**September 14<sup>th</sup>, 2023**

**Midland ESA Additions & Renovations  
Addenda #3**

**TRC Narrative**

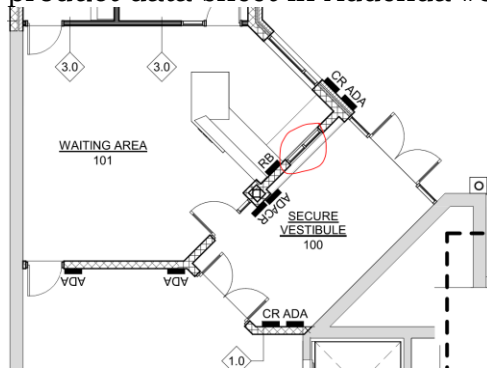
- Shall fabricate & install custom doors at Enclosed playground and Mechanical Enclosure, refer to RFI #55

SHEET TITLE  
DEMOLITION PLAN -  
AREA A - LOWER LEVEL

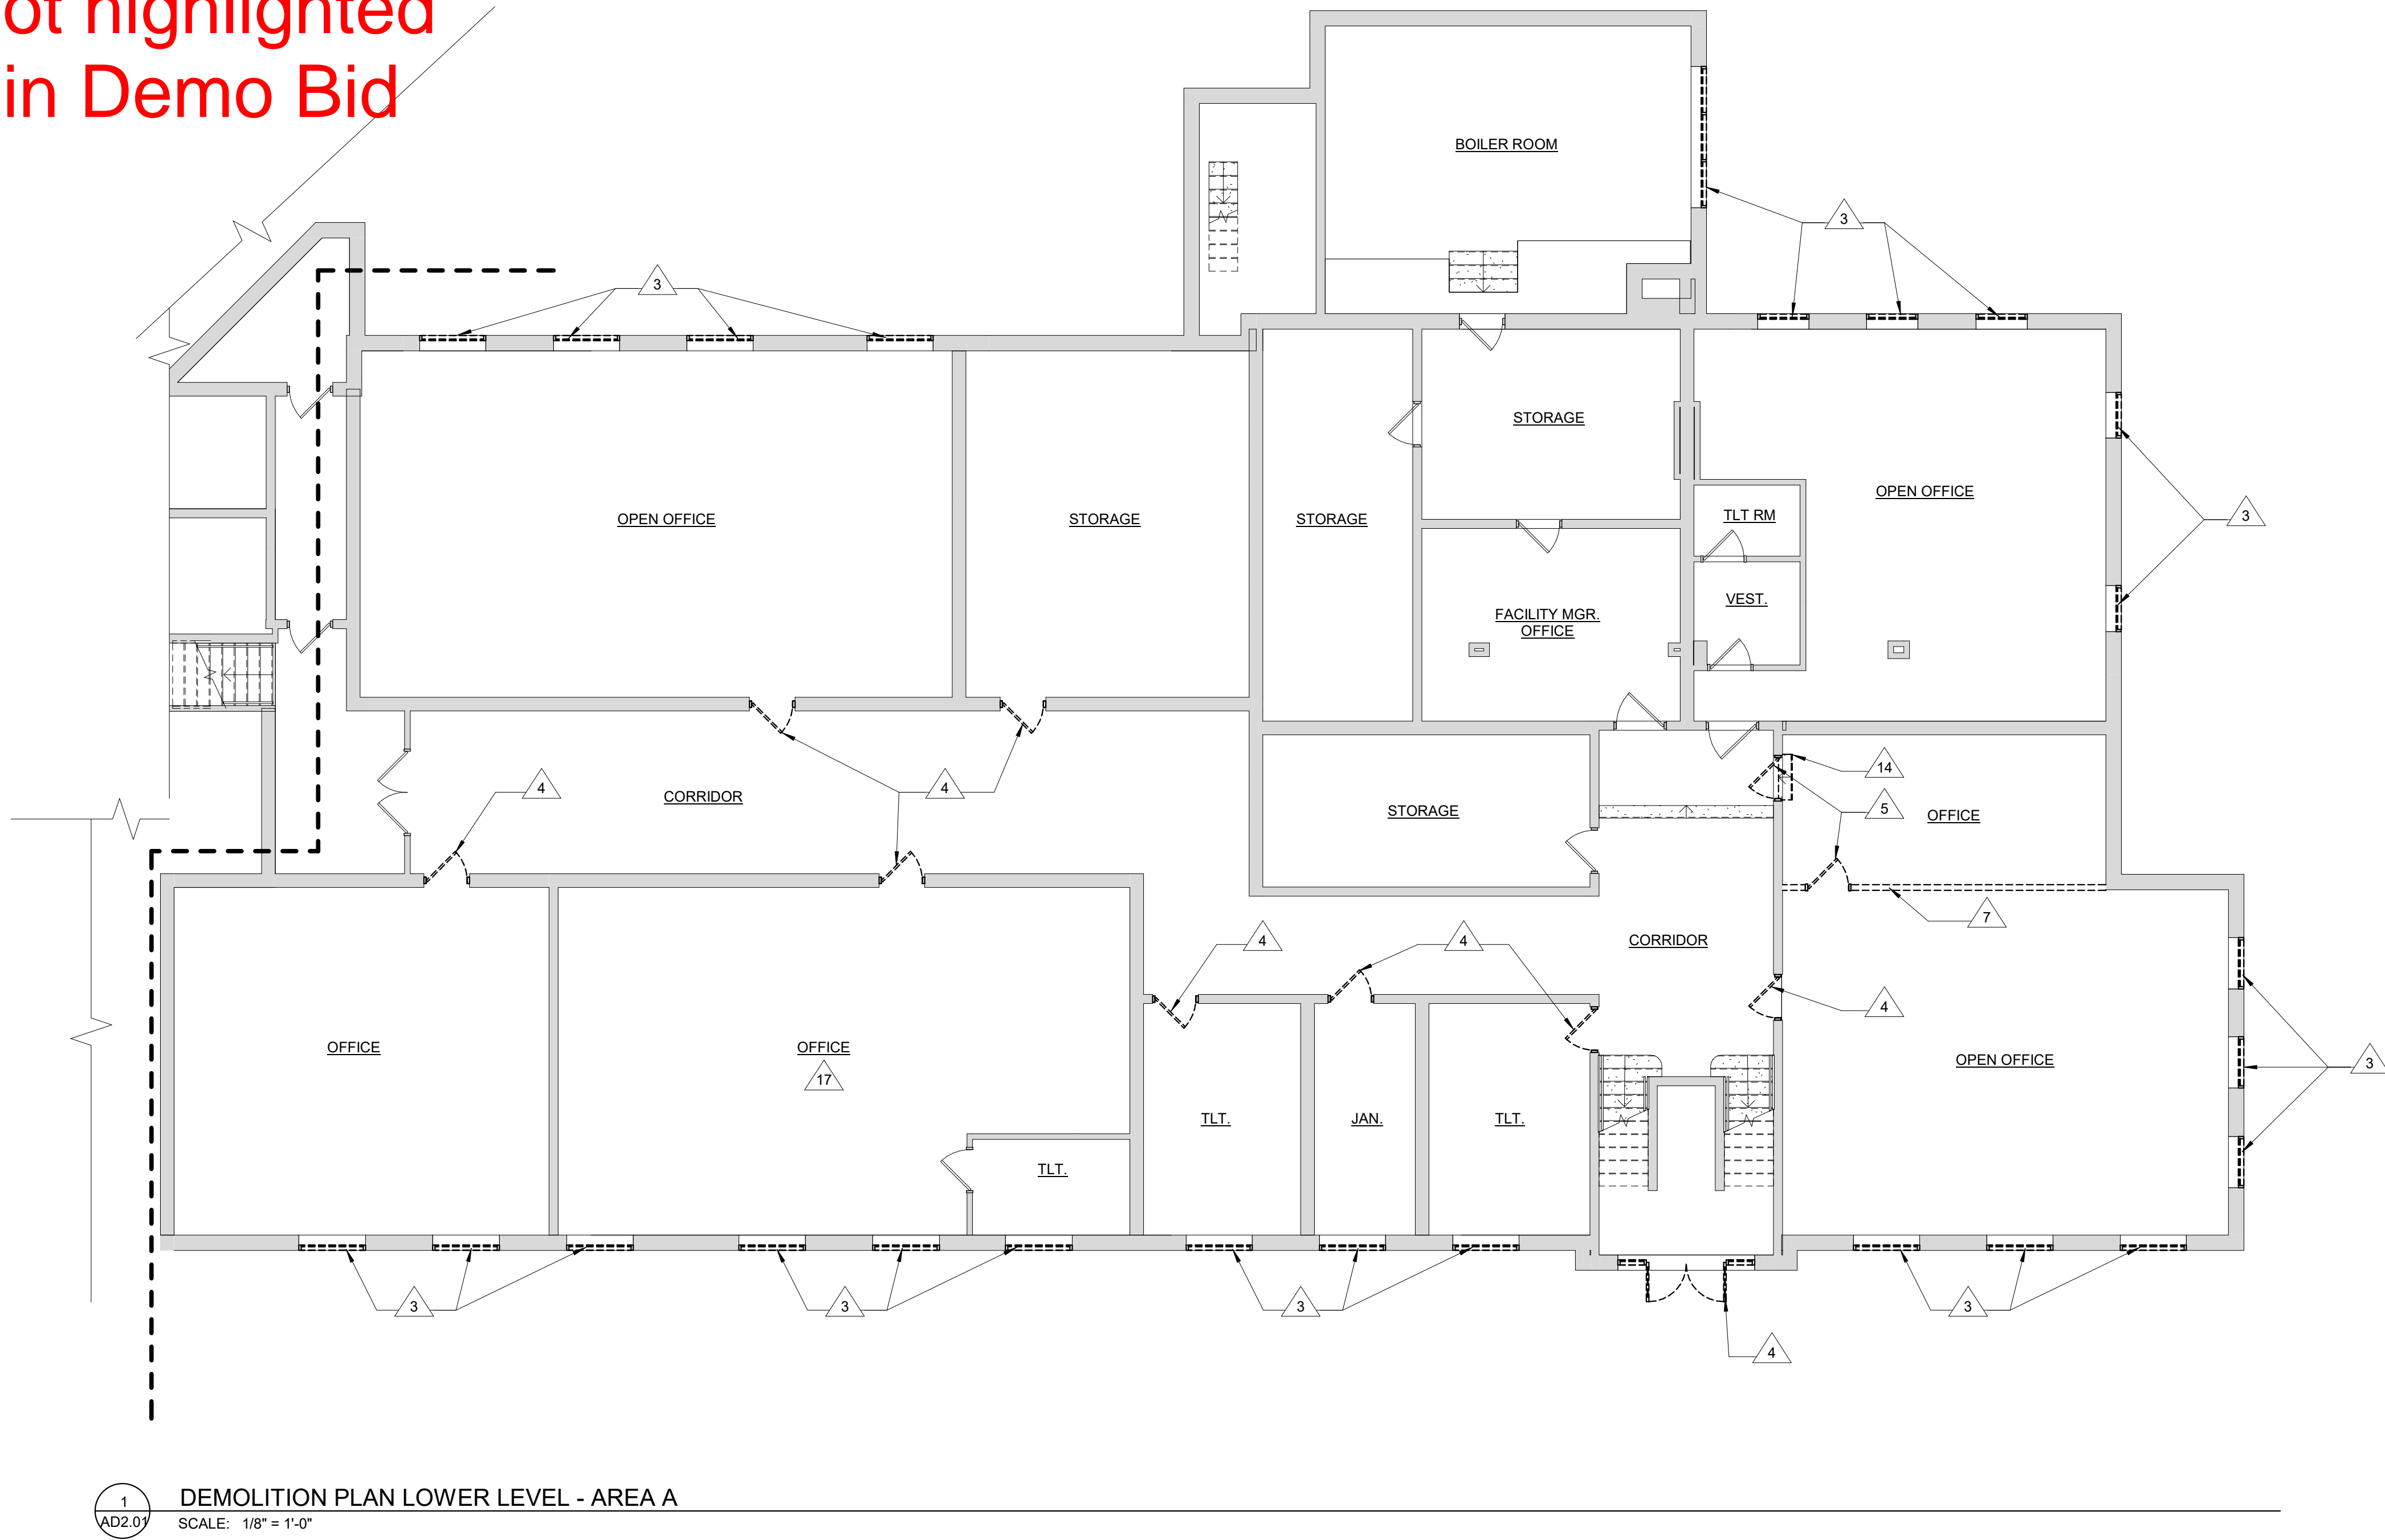
Highlighted areas to be included by Masonry package for interior demo/toothing.

Not representative of all "infill" work , review wall details on floor plans for other masonry infill areas.

All other wall demo not highlighted is to be included within Demo Bid Package.

1  
AD2.03  
DEMOLITION PLAN UPPER LEVEL - AREA A  
SCALE: 1/8" = 1'-0"

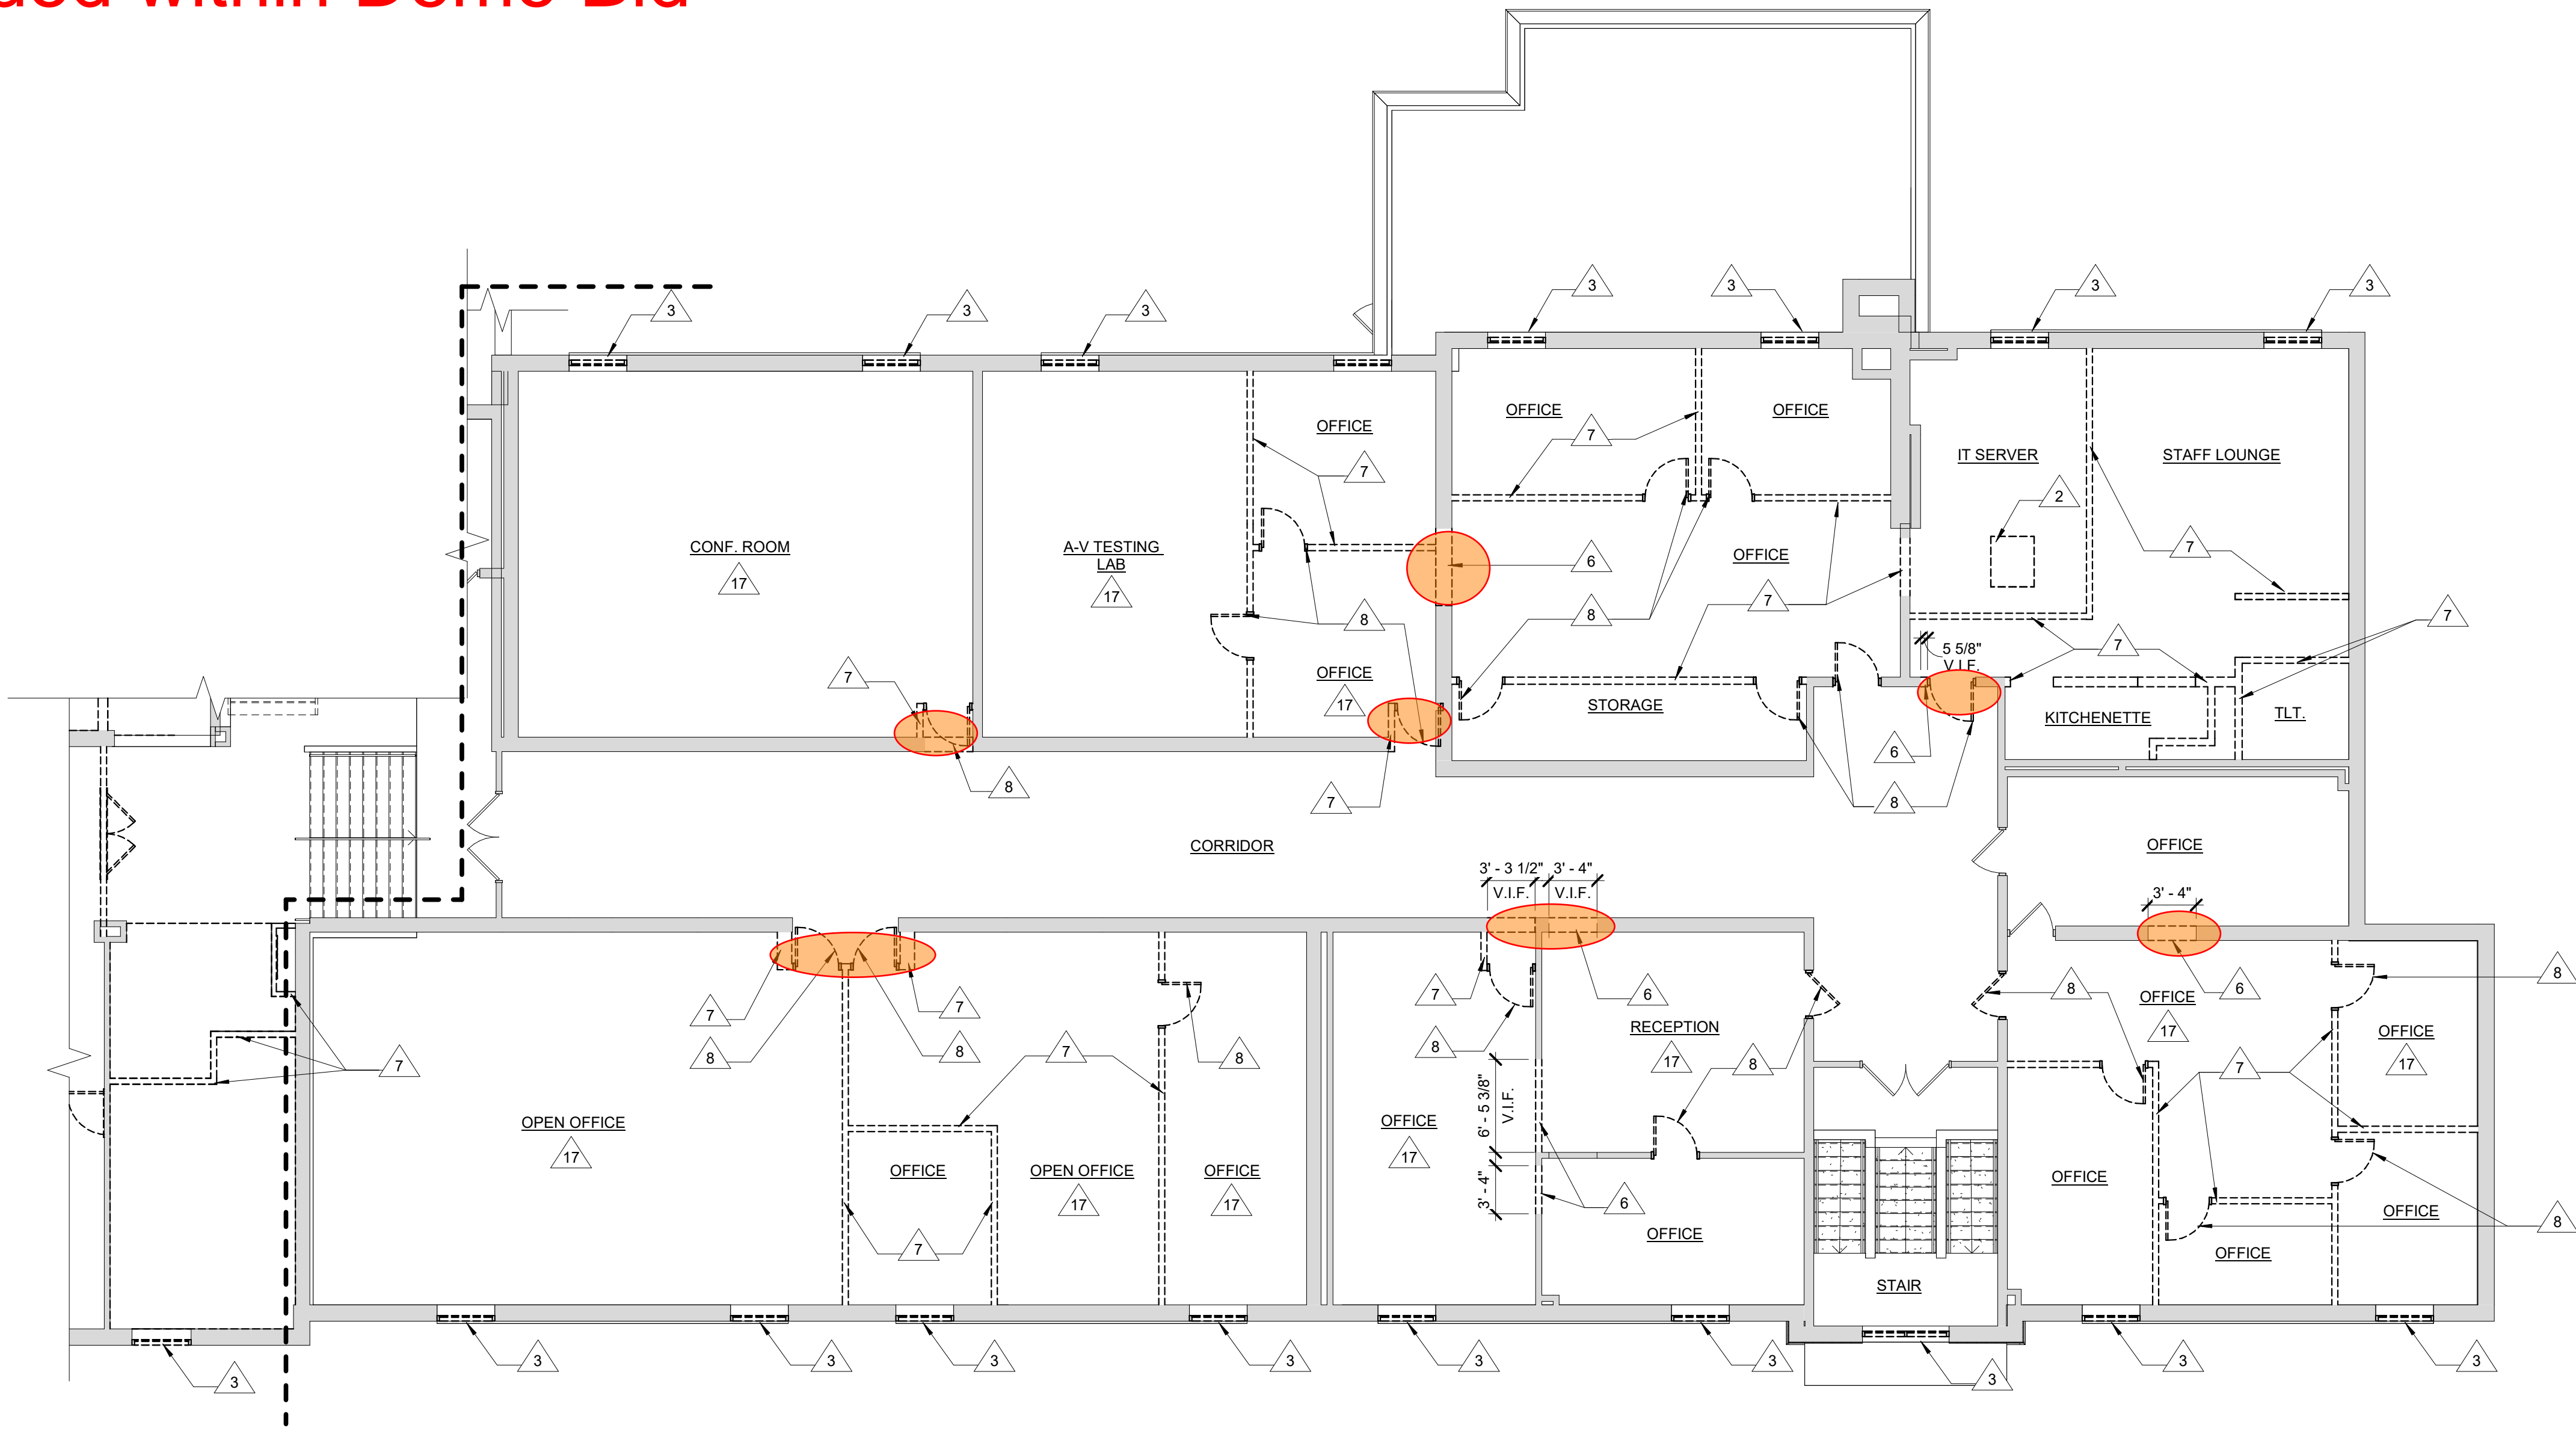
Highlighted areas to be included by Masonry package for interior demo/toothing.

Not representative of all "infill" work , review wall details on floor plans for other masonry infill areas.

All other wall demo not highlighted is to be included within Demo Bid Package.

1 DEMOLITION PLAN UPPER LEVEL - AREA B  
AD2.04 SCALE: 1/8" = 1'-0"

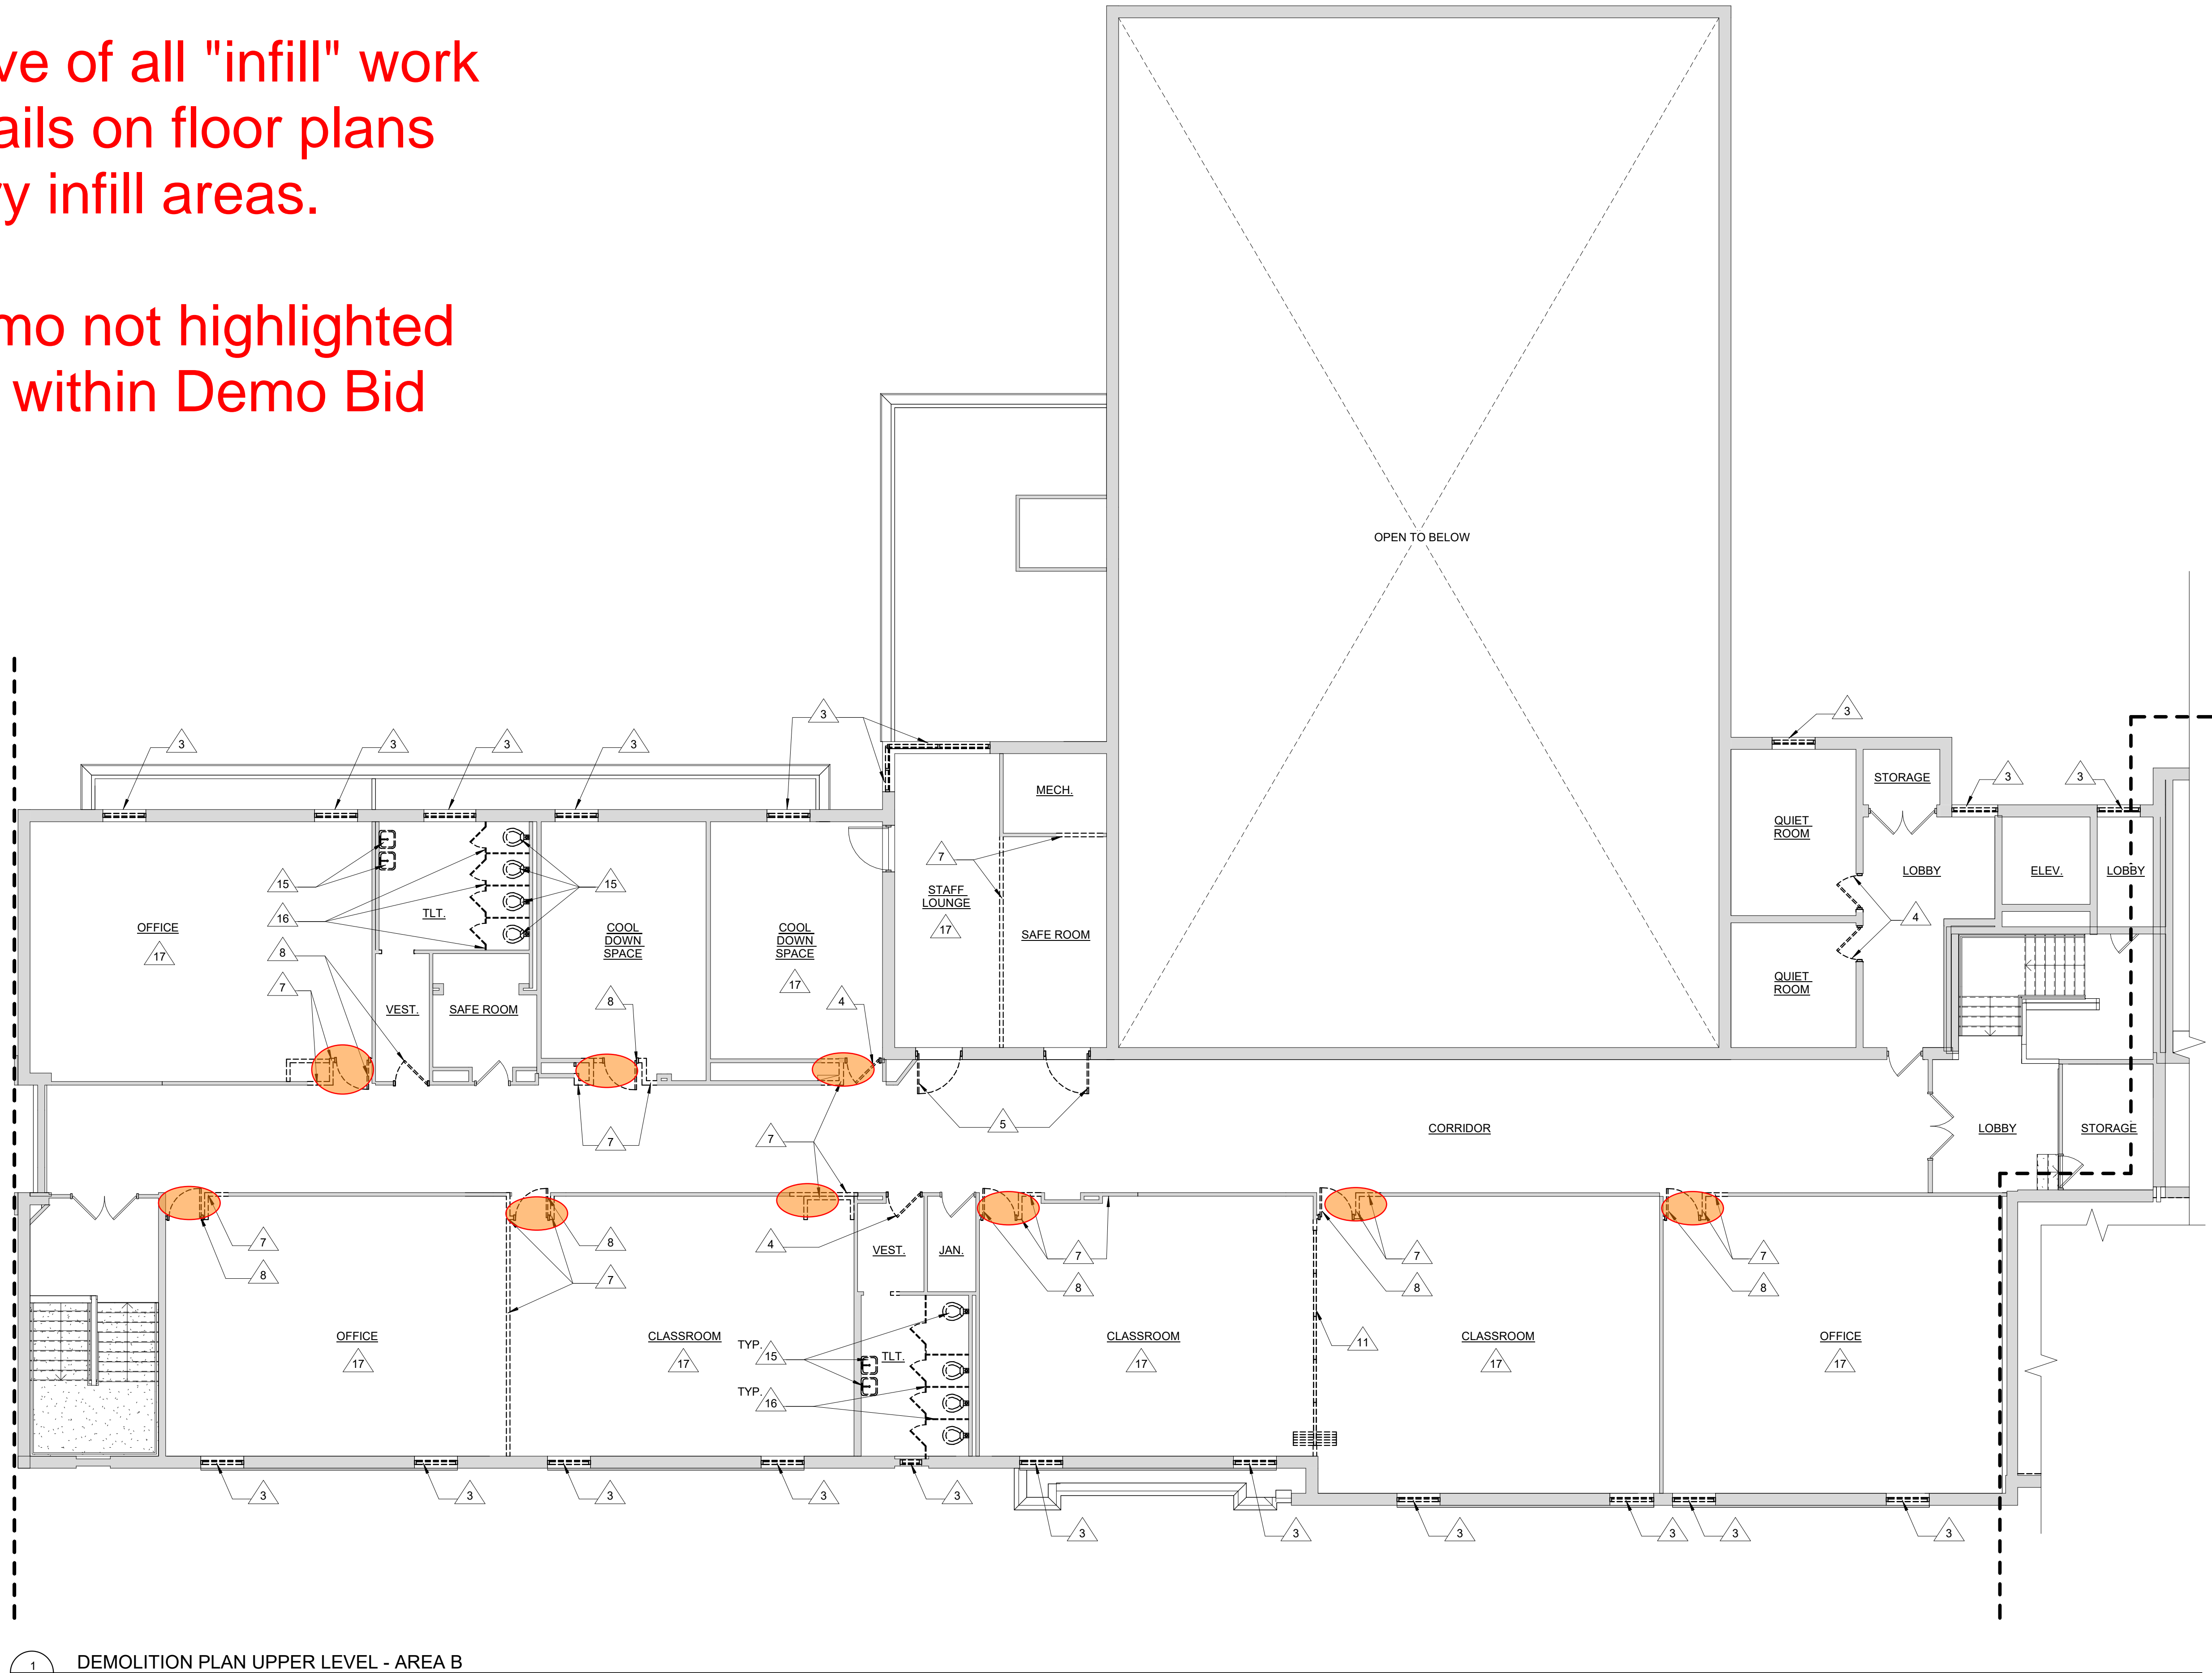
Highlighted areas to be included by Masonry package for interior demo/toothing.

Not representative of all "infill" work , review wall details on floor plans for other masonry infill areas.

All other wall demo not highlighted is to be included within Demo Bid Package.
